City of Ketchum
Planning & Building

IN RE:)
)
 Warm Springs Ranch Residences Lot 35) **KETCHUM PLANNING & ZONING COMMISSION**
 Design Review) **FINDINGS OF FACT, CONCLUSIONS OF LAW, AND**
 Date: September 26, 2023) **DECISION**
)
 File Number: P23-020)

PROJECT: Warm Springs Ranch Residences Lot 35
 FILE NUMBER: P23-020
 APPLICATION TYPE: Design Review
 REPRESENTATIVE: John Shirley – Think Architecture (architect)
 PROPERTY OWNER: Brennan Holdings No. 300 LLC
 LOCATION: 190 Bald Mountain Road (Lot 35, Block 4, Warm Springs Ranch Residences)
 ZONING: General Residential – Low Density (GR-L)
 OVERLAY: None

SHEET NUMBER:
A101

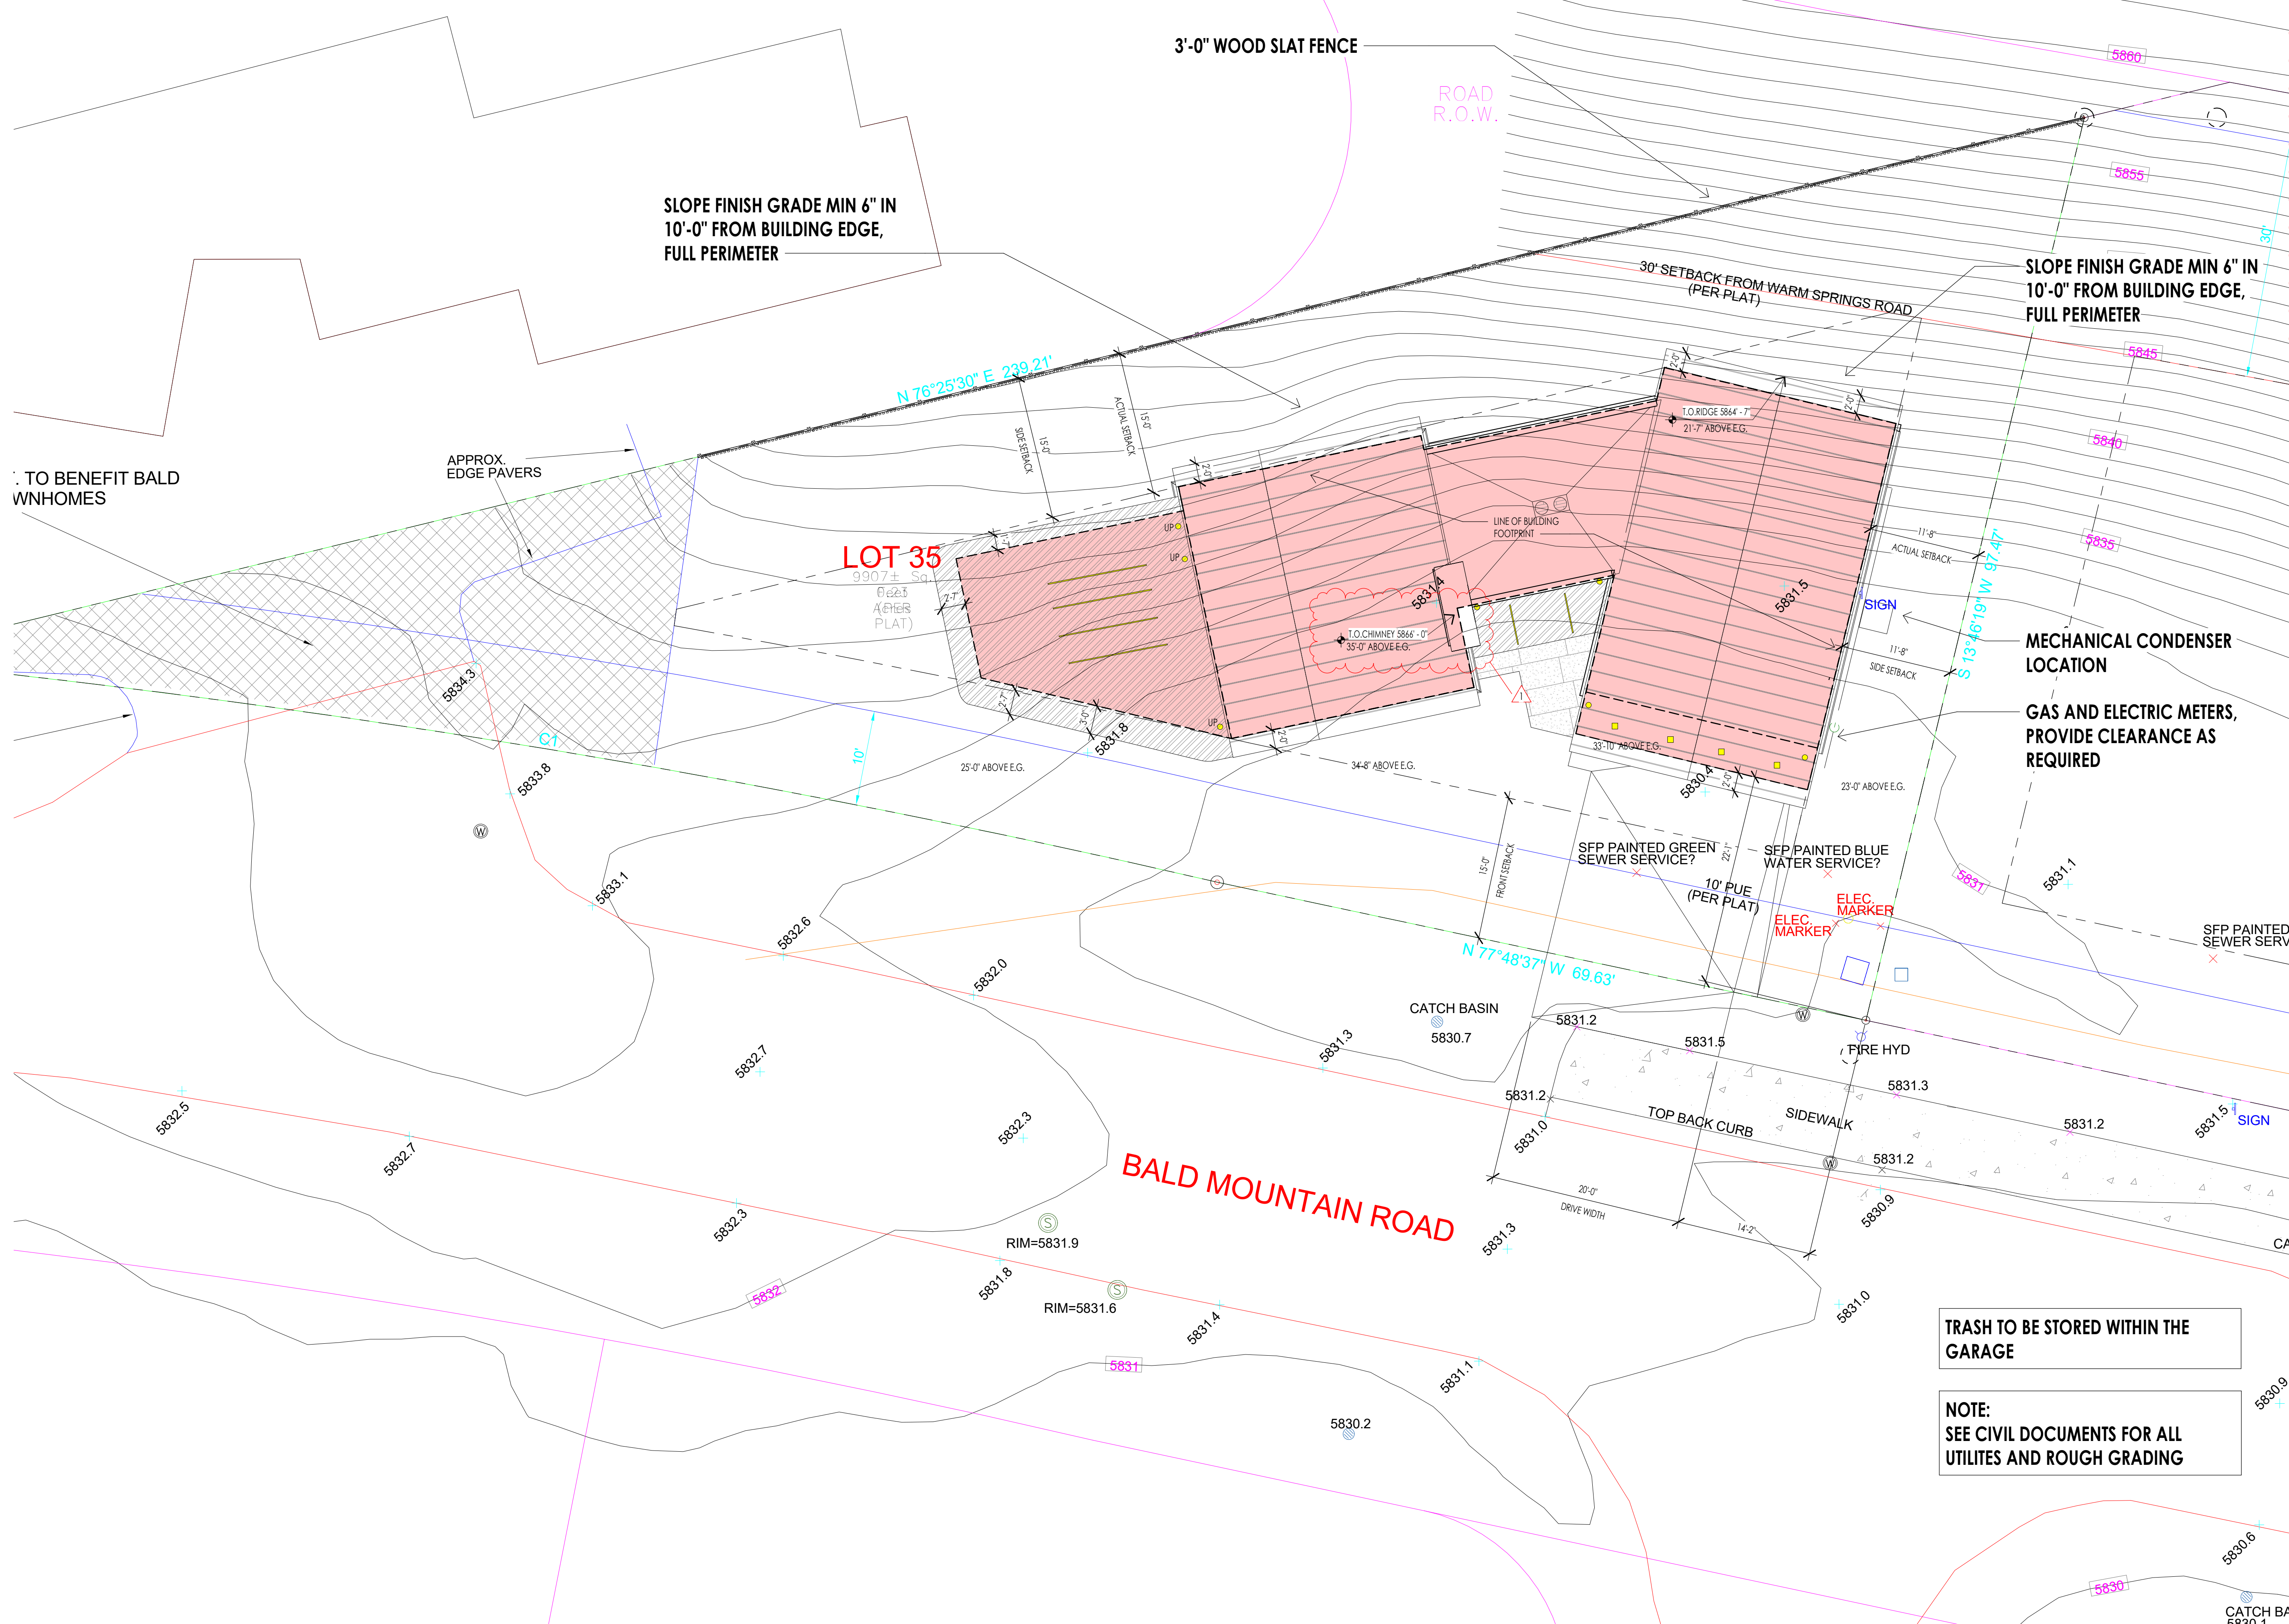
17.96.060.F.7 – Architectural	Conformance
<i>Garbage storage areas and satellite receivers shall be screened from public view and located off alleys.</i>	YES
Finding: No satellite receivers are proposed for the project. Sheet A101 of the project plans indicates that garbage bins will be stored within the garage and screened from public view.
